[REDACTED]  
Subject: RE: Chapel Lane Soakage

CHAPEL LANE, STANDLAKE  
MR PATRICK STEEPE  
MARCH 2021  
4212-CHAP-ICS-XX-RP-C-07.001-P07

**Drainage Strategy**

PROJECT: Chapel Lane, Standlake

# GROUNDWATER MONITORING - PAGE 1

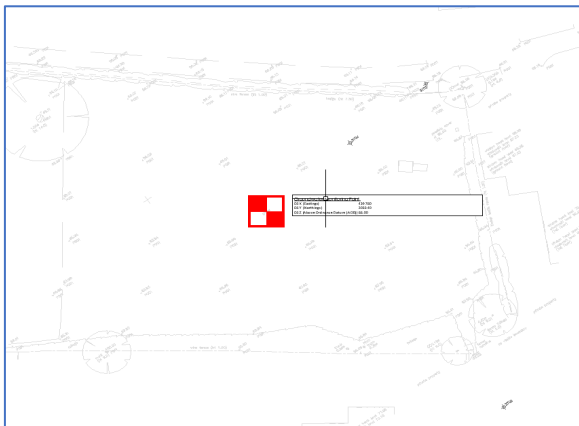
Unfortunately, with the very large number of flooding-related objections received for this latest application, a handwritten note of groundwater depths without corroborating borehole logs is not going to be sufficient to satisfy the concerns, especially as the same figure (590mm) keeps cropping up. Although a further soakage test has been carried out which indicates similar infiltration to before, formal evidence that groundwater will not be an insurmountable issue is required to be submitted before I can remove my objection.

Date	Measurement from ground level to water/mm	Approximate level (Above Ordnance Datum [AOD])/m
26 November 2022	590	65.41
10 December 2022	590	65.41
24 December 2022	590	65.41
07 January 2023	590	65.41
21 January 2023	590	65.41
04 February 2023	735	65.27
18 February 2023	800	65.20
28 February 2023	800	65.20
06 October 2023	1020	64.98
13 October 2023	900	65.10
24 October 2023	880	65.12
27 October 2023	740	65.26
03 November 2023	670	65.33
10 November 2023	590	65.41
17 November 2023	590	65.41
24 November 2023	670	65.33
01 December 2023	670	65.33
08 December 2023	590	65.41
20 December 2023	595	65.41
26 December 2023	670	65.33
02 January 2024	330	65.67

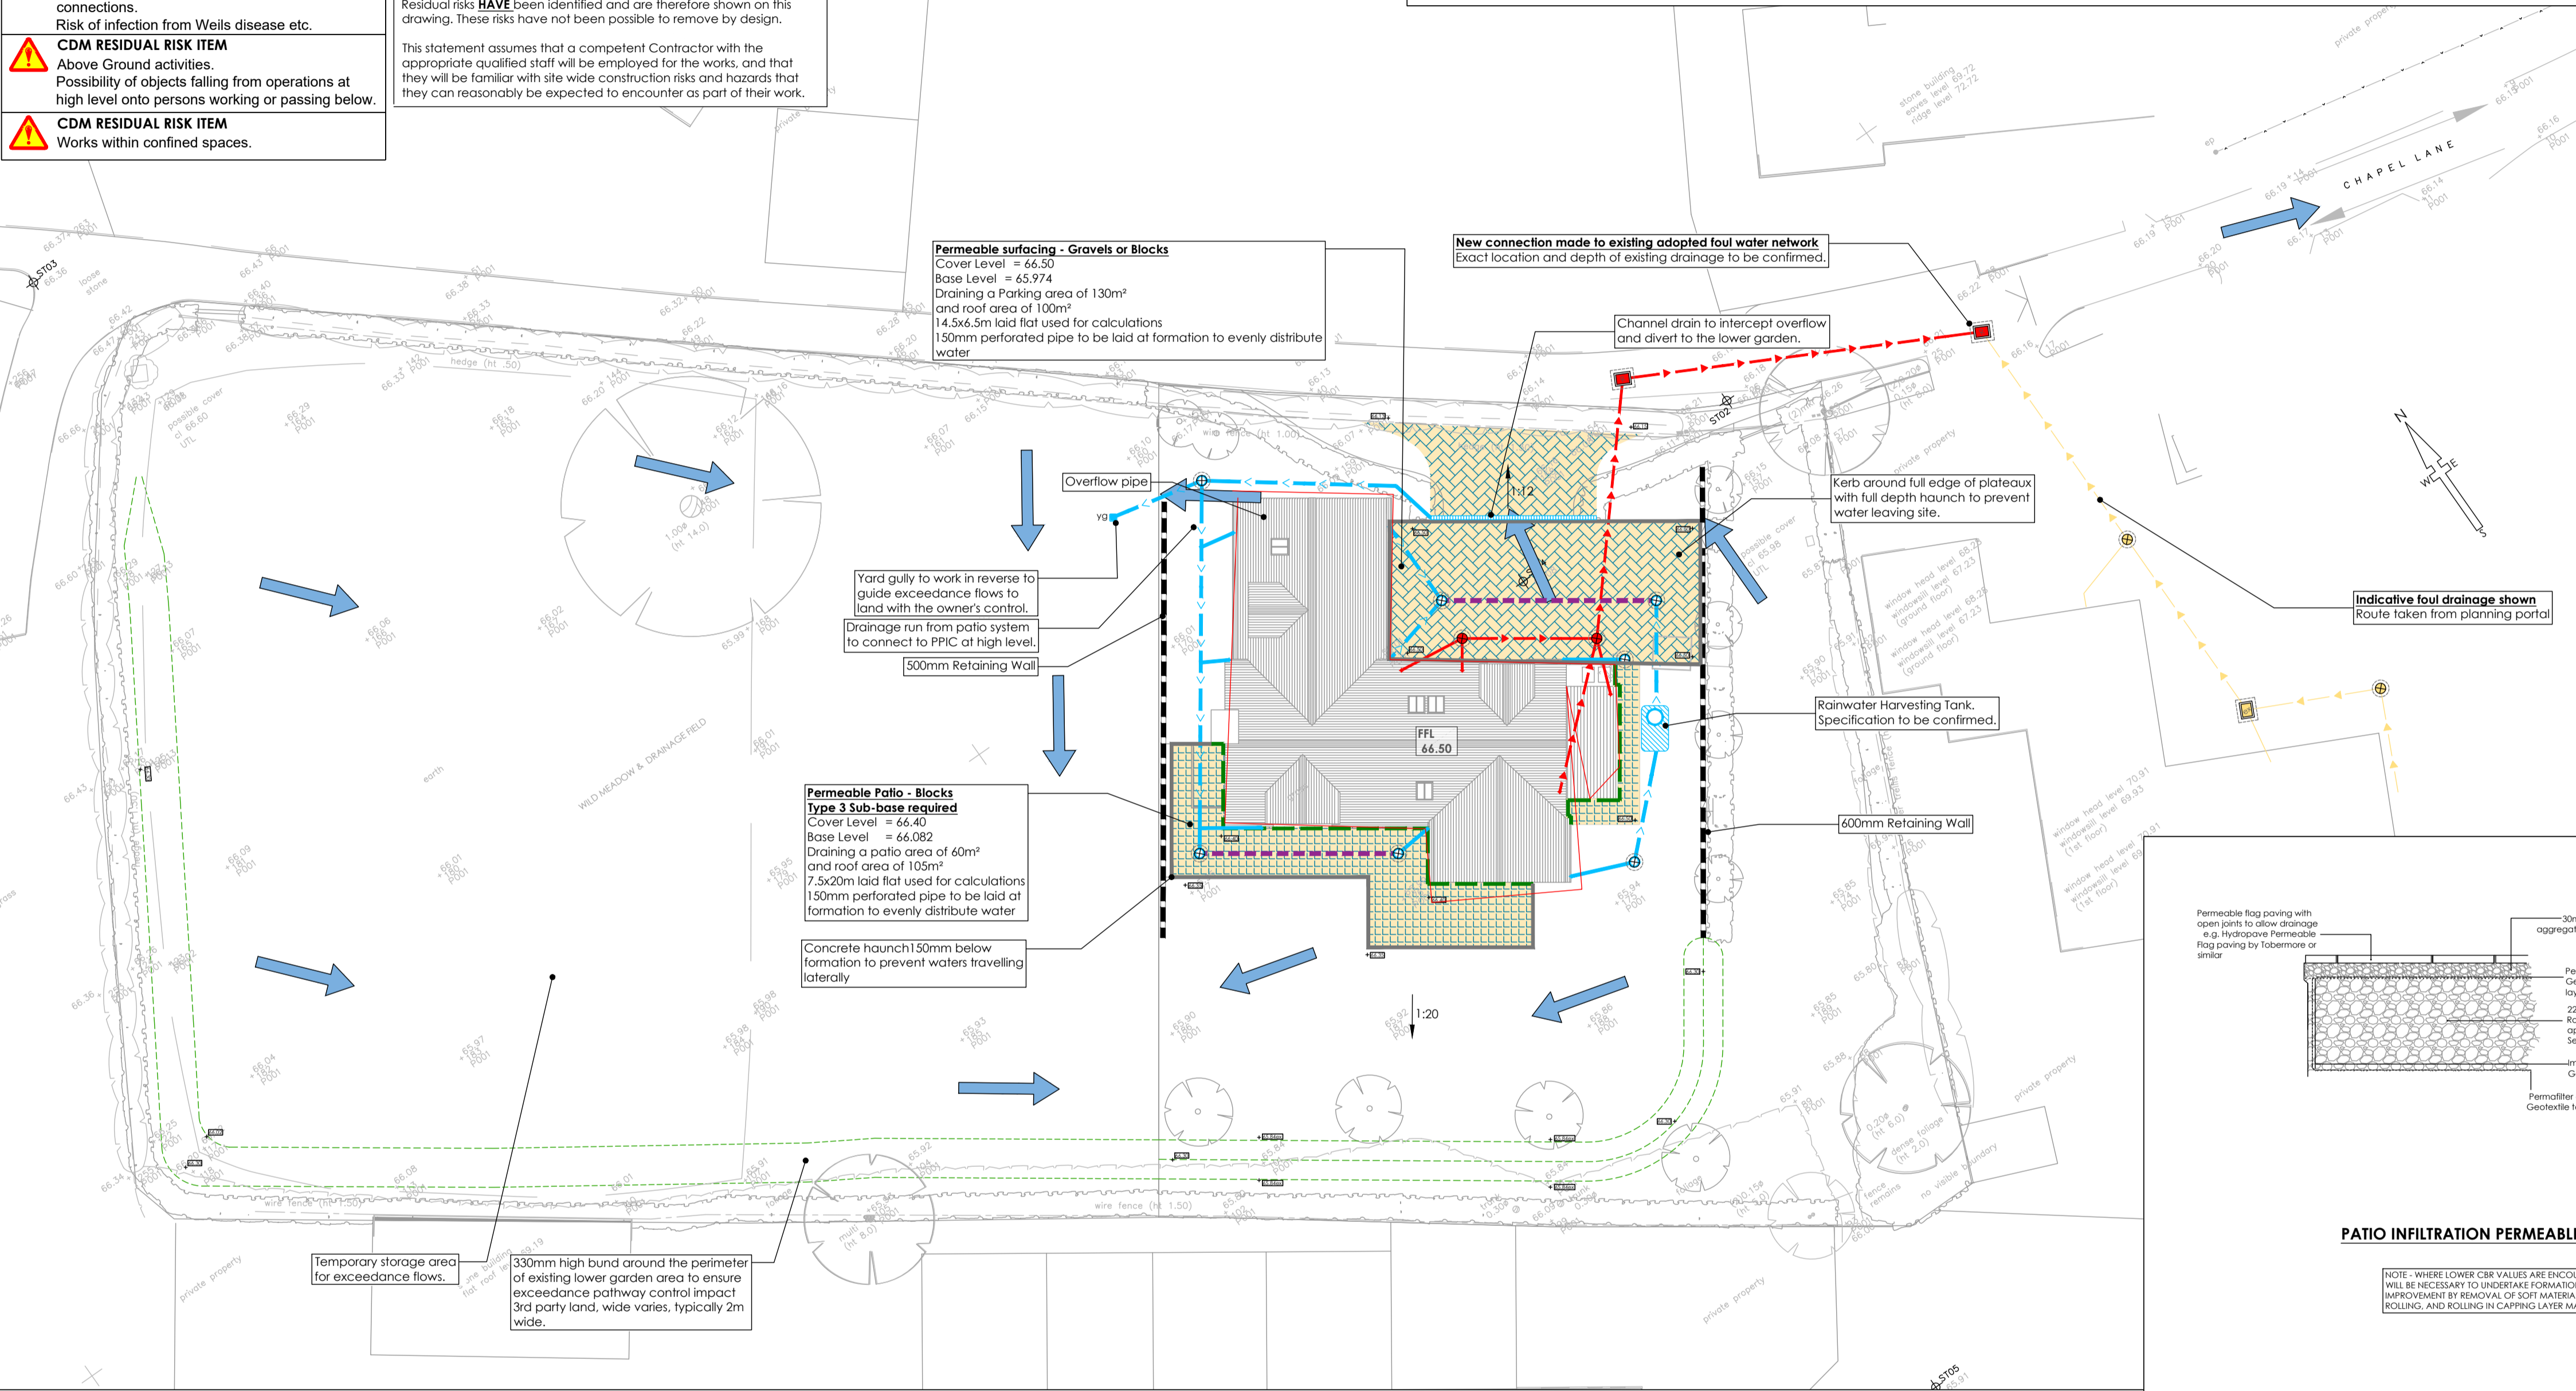
As you have stated it is proposed to raise levels of the lower site, can you please confirm by how much it is currently proposed to raise them by and whether the latest groundwater reading has been taken into consideration with regards to the base level of the permeable paving, i.e. is there any scope for raising the ground levels further?

The current design achieves 304mm clearance of the base of the infiltration feature and the highest recorded groundwater level (this week). The latest reading has been taken into account with the current design.

The parking is already 420mm higher than the existing ground level at the location of the paving (it was 66.08, it will be 66.50).

To the rear of the dwelling is 550mm higher, the existing levels are currently 65.95, and the FFL is proposed to be 66.50.

**DESIGN NOTE**  
 Peak groundwater encountered 330mm below ground level from a surface level of 66.00m. Indicating a peak groundwater level between November 2022 and January 2024 of 65.67

**DESIGN NOTE**  
 A paving level of 66.50 gives an 304mm freeboard between base of infiltration feature and highest recorded ground water level
